Attachment 1
NRC3-13-0015
(191 pages)

FSAR Markups

The following markup represents how DTE Electric intends to reflect this RAI response in the next submittal of the Fermi 3 COLA. However, the same COLA content may be impacted by responses to other COLA RAIs, other COLA changes, plant design changes, editorial or typographical corrections, etc. As a result, the final COLA content that appears in a future submittal may be different than presented here.

Figure 2.5.1-207 Regional Seismicity and Tectonic Features in the Fermi 3 Site Region (Sheet 1 of 3)

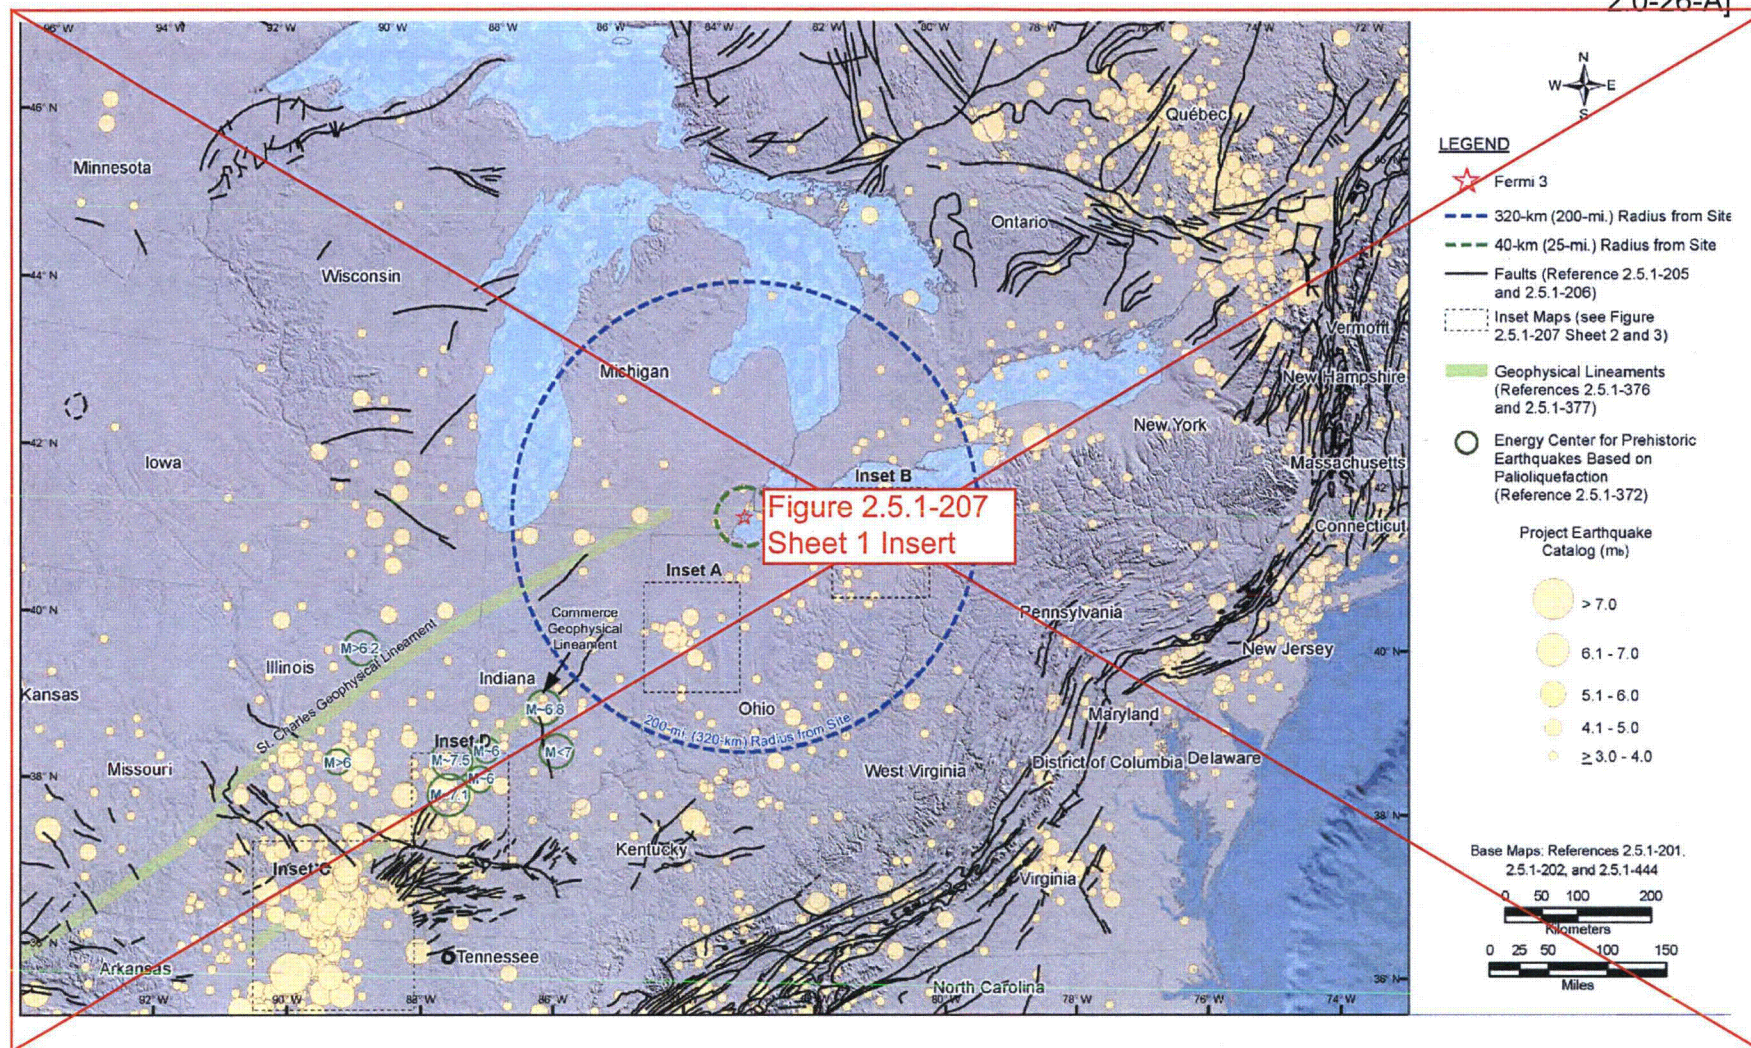
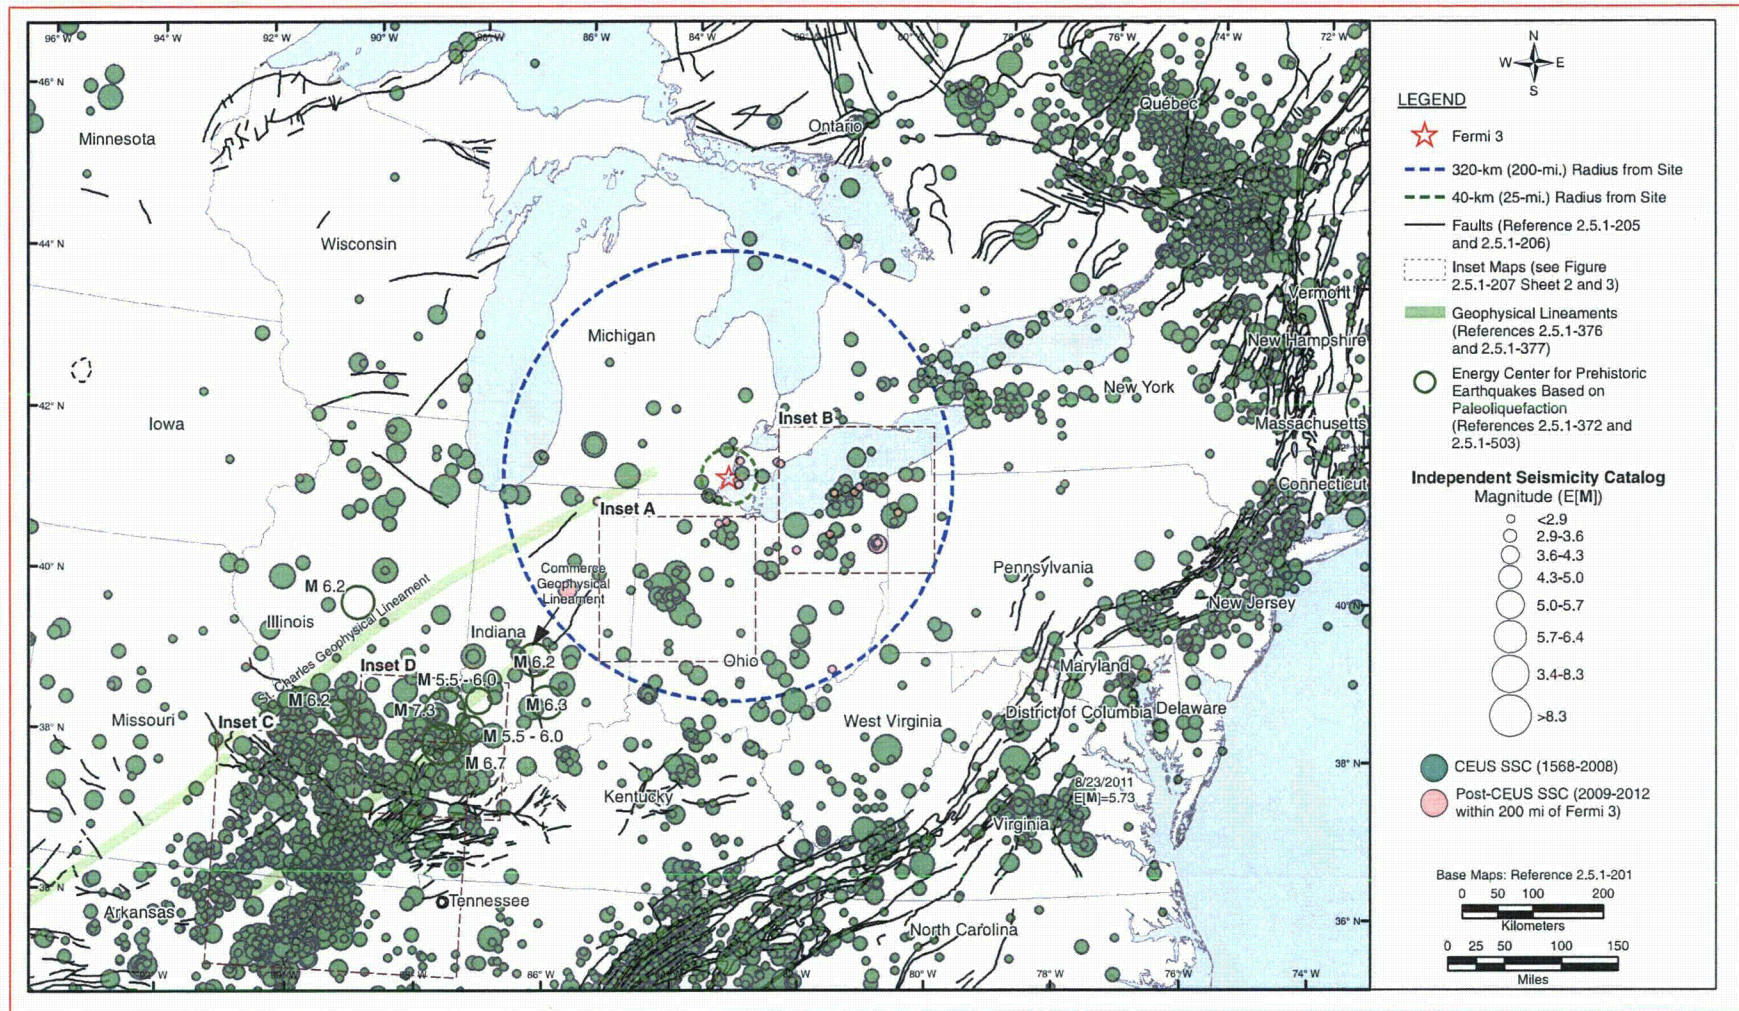
Figure 2.5.1-207 Sheet 1 Insert

Figure 2.5.1-207 Regional Seismicity and tectonic Features in the Fermi 3 Site Region (Sheet 2 of 3)[EF3 COL 2.0-26-A]

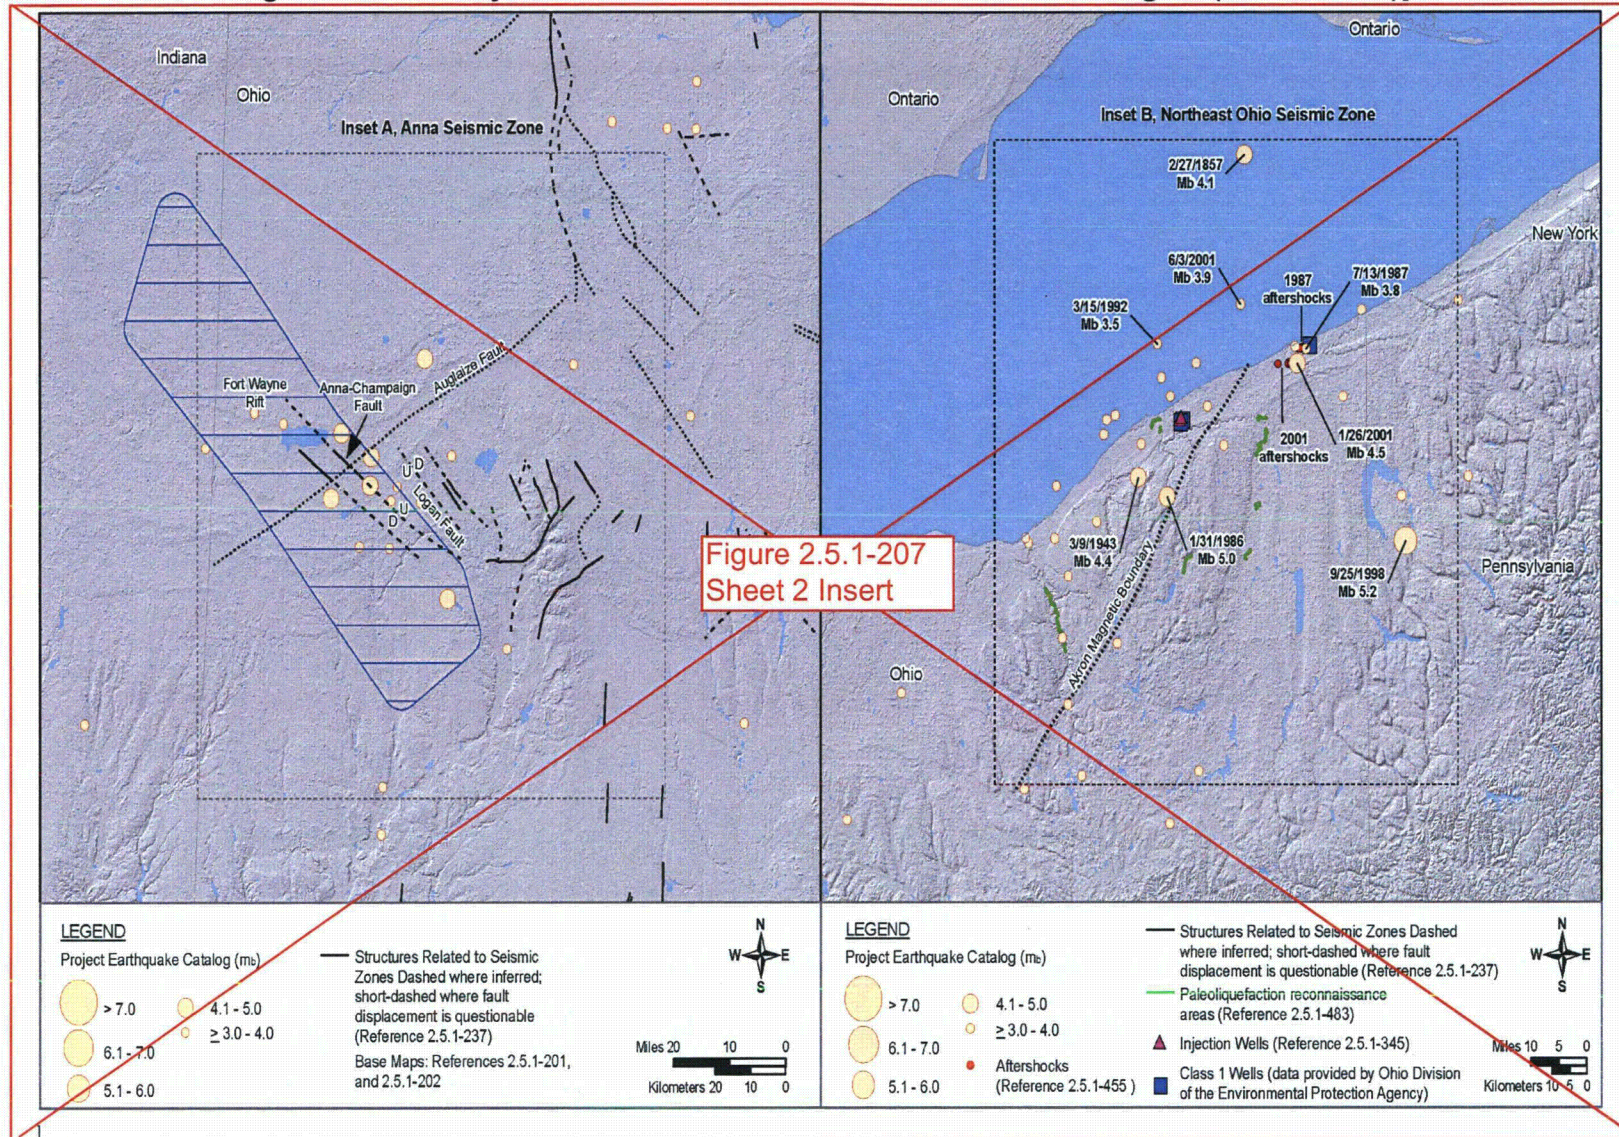
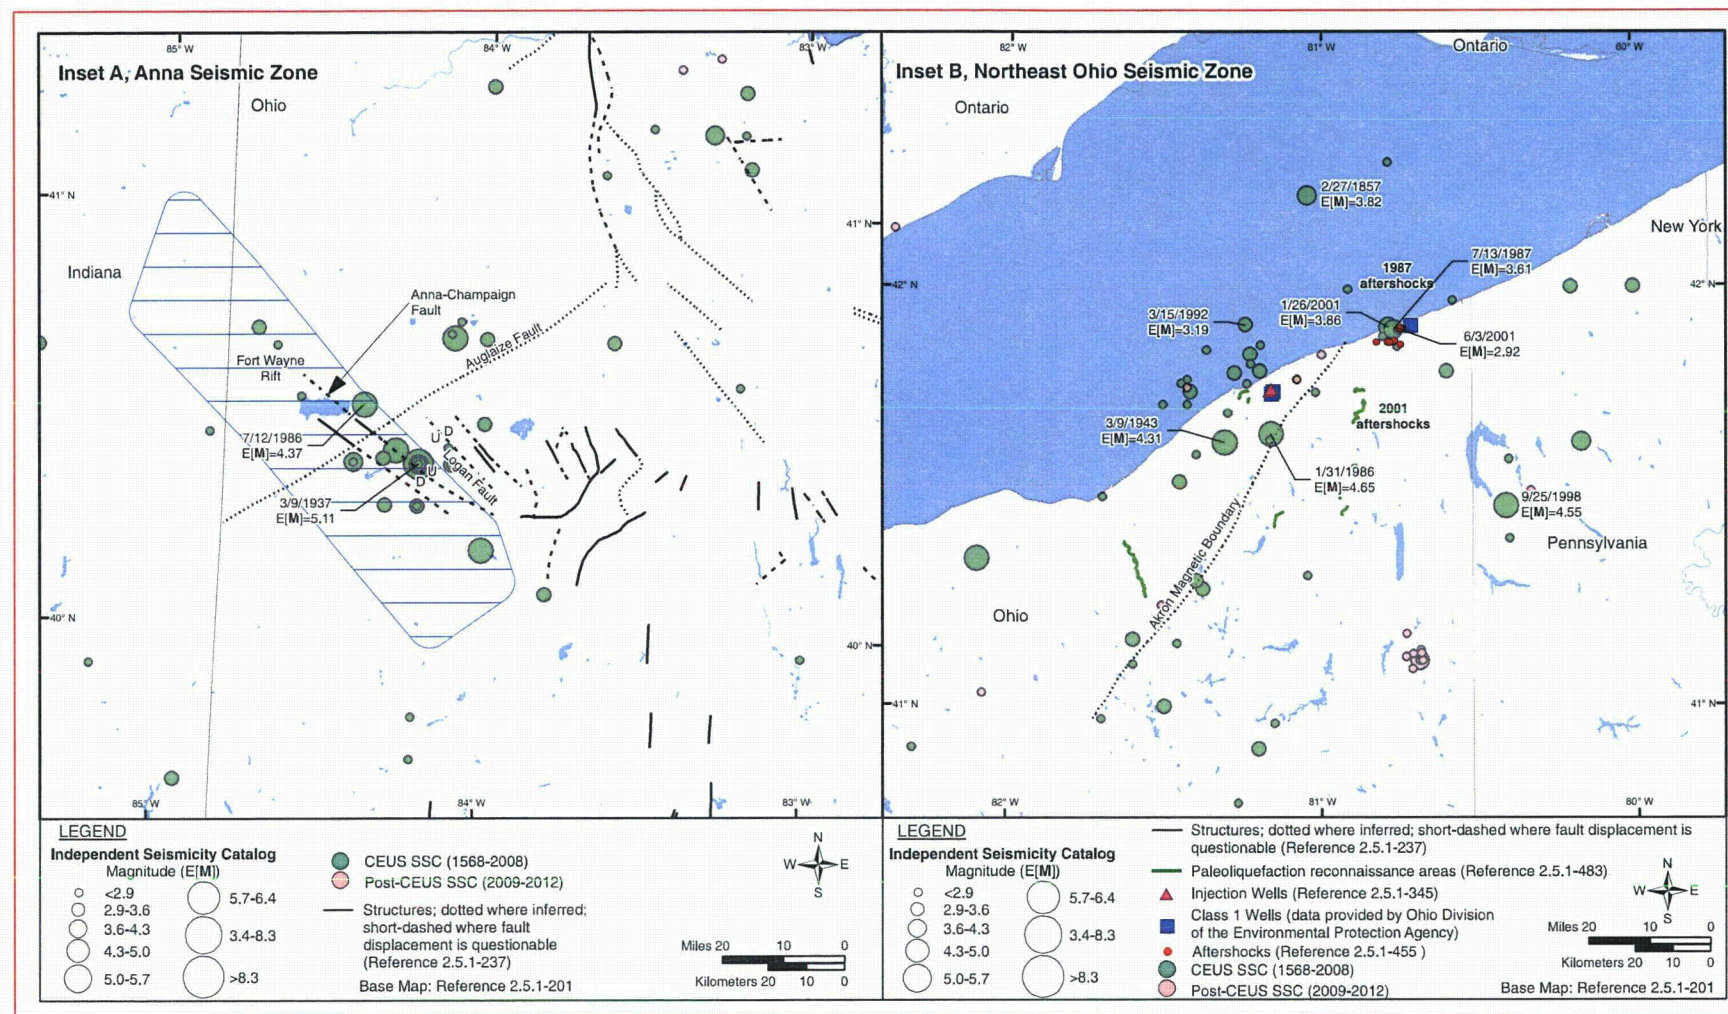
Figure 2.5.1-207 Sheet 2 Insert

Figure 2.5.1-207 Regional Seismicity and tectonic Features in the Fermi 3 Site Region (Sheet 3 of 3)[EF3 COL 2.0-26-A]

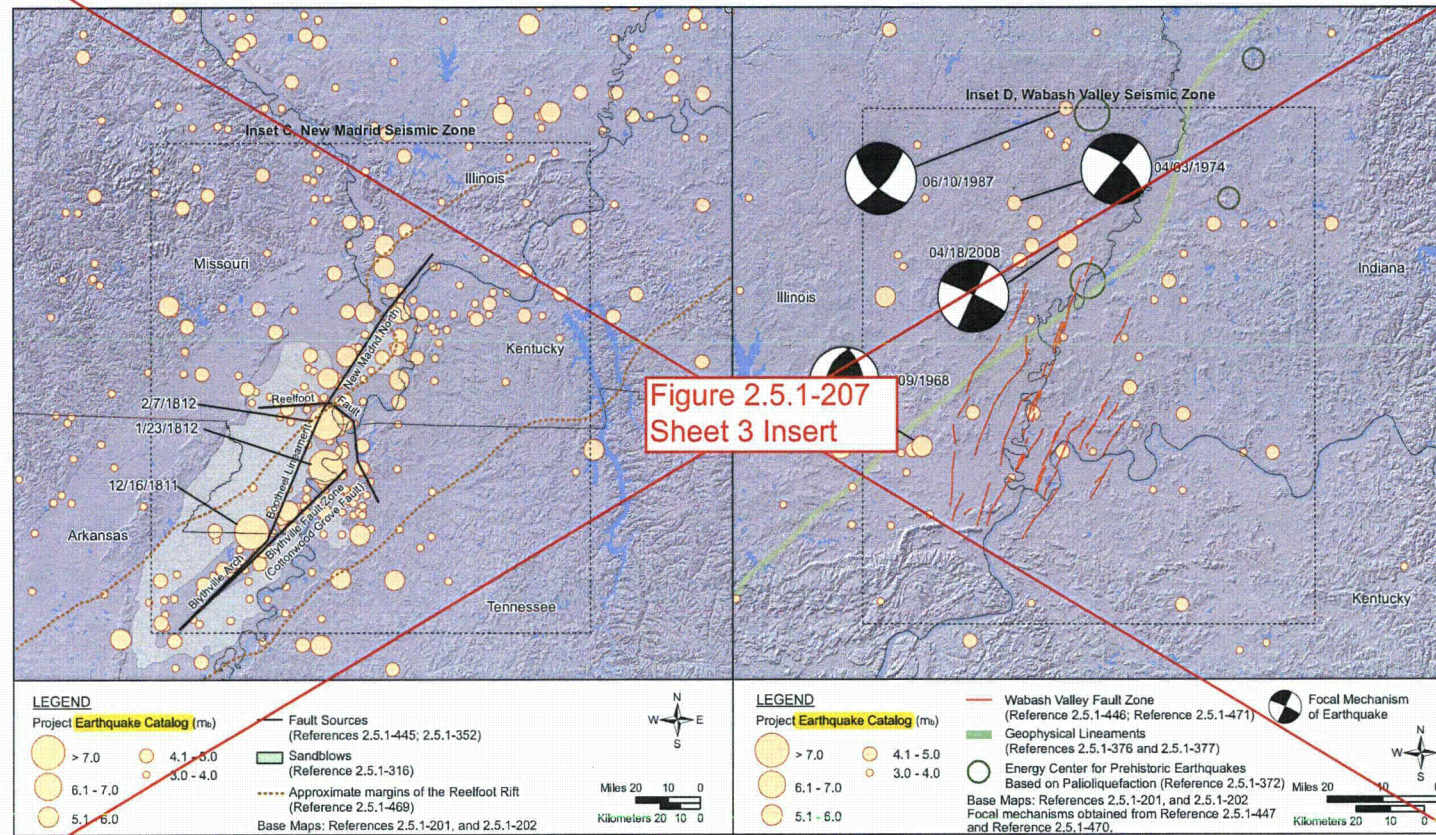
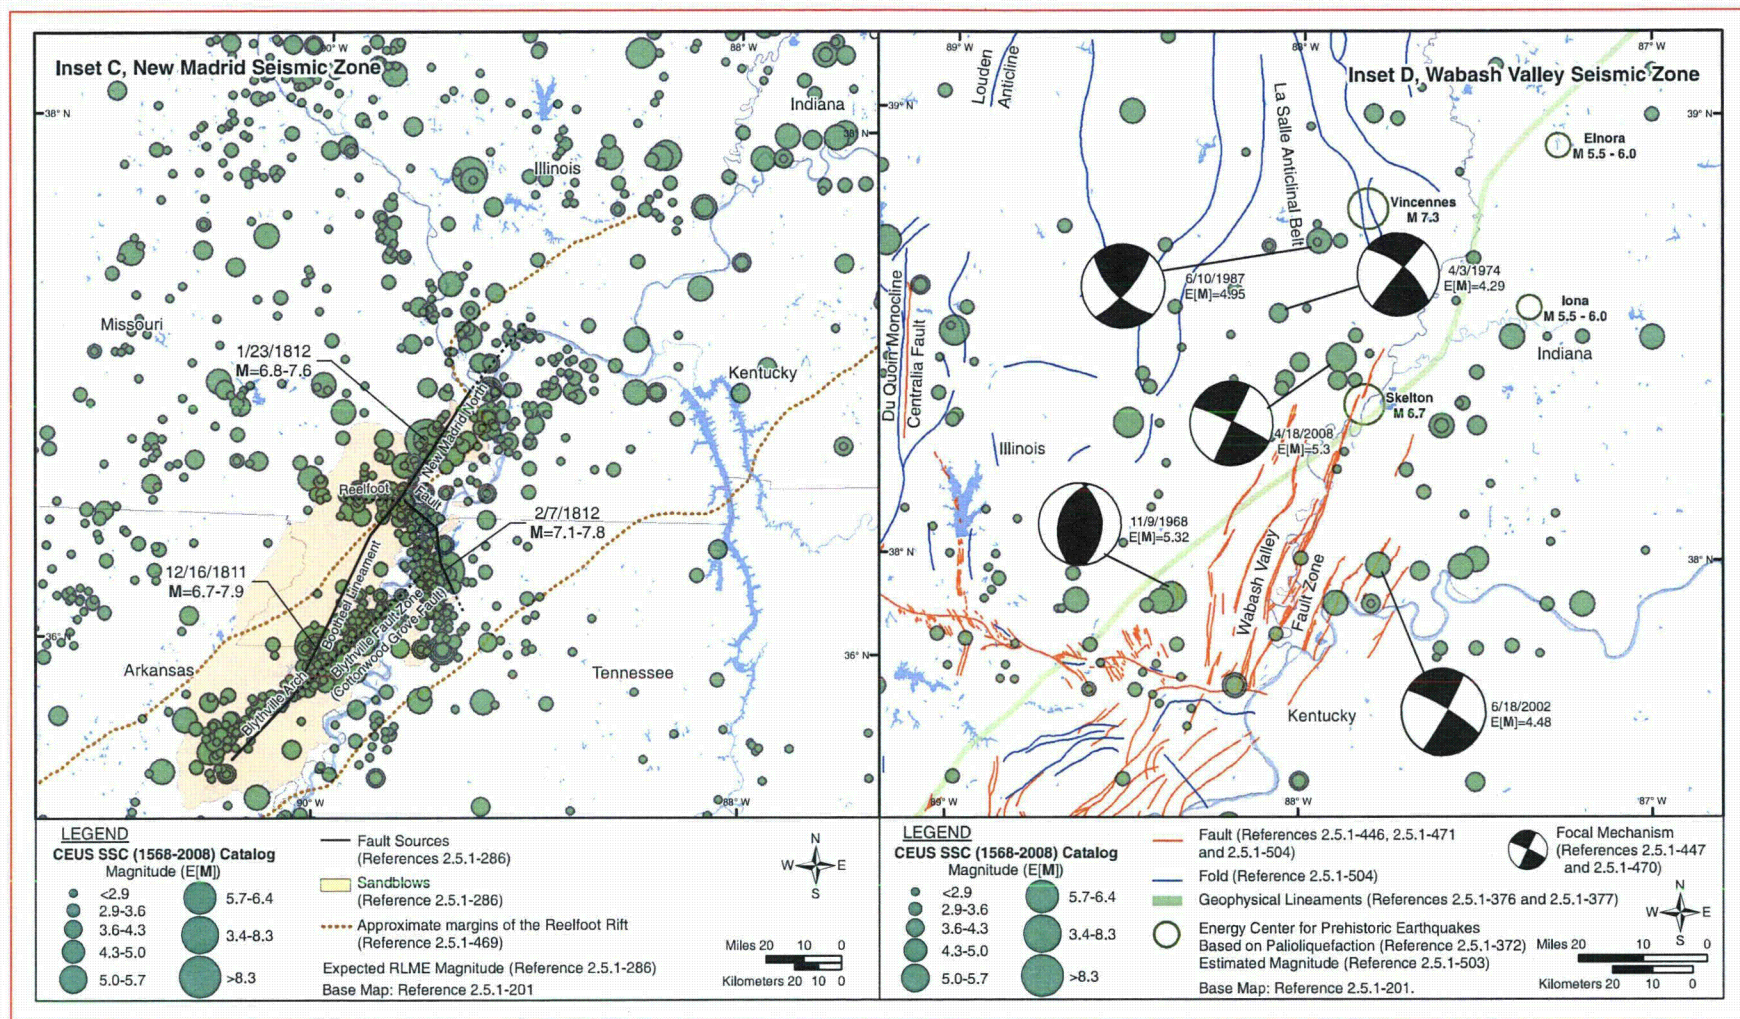
Figure 2.5.1-207 Sheet 3 Insert
